REVISED RESPONSE TO REQUEST FOR ADDITIONAL INFORMATION

APR1400 Design Certification

Docket No. 52-046

RAI No.: 226-8235
SRP Section: 03.07.02 – Seismic System Analysis
Application Section: 3.7.2
Date of RAI Issue: 09/25/2015

Figure 1 The FE model for RCS in SSI and structural analyses

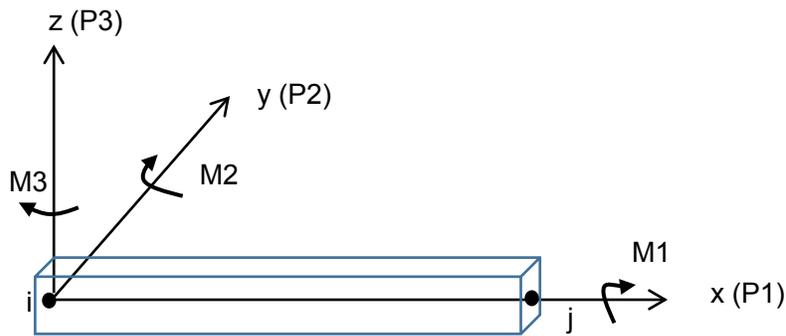
To assist the staff in evaluating whether the aforementioned masses and their effect have been adequately considered in the seismic analysis and design, the staff requests the applicant to clarify if these masses are included in or excluded from the FEMs used in the SSI analyses. If the hydrodynamic masses were included in the FEMs used in the SSI analyses, describe the process used to estimate the slosh height. If the masses described in the paragraph above are excluded from the FEMs used in the SSI analyses, describe the process (including a numerical example) for developing design loads that correspond to these masses and how these loads are combined with the seismic design loads. Additionally and as necessary, correct any inconsistencies between the aforementioned technical reports.

The RCS FE model (same as in SSI model) is included in the structural analysis model for the internal structure in order to consider the effect of RCS mass, as shown in Figure 1. It is made up of beam elements (BEAM4 in ANSYS) and mass elements. To connect the RCS model and internal structure, the rigid beams shown in yellow in Figure 1 are used. Table 1 summarizes the comparison of member end forces from the SSI analysis to those from the structural analysis at the major RCS frame supports.

Since the results of member end forces in the structural analysis are greater than those in the SSI analysis, the RCS masses are adequately considered in the structural design.
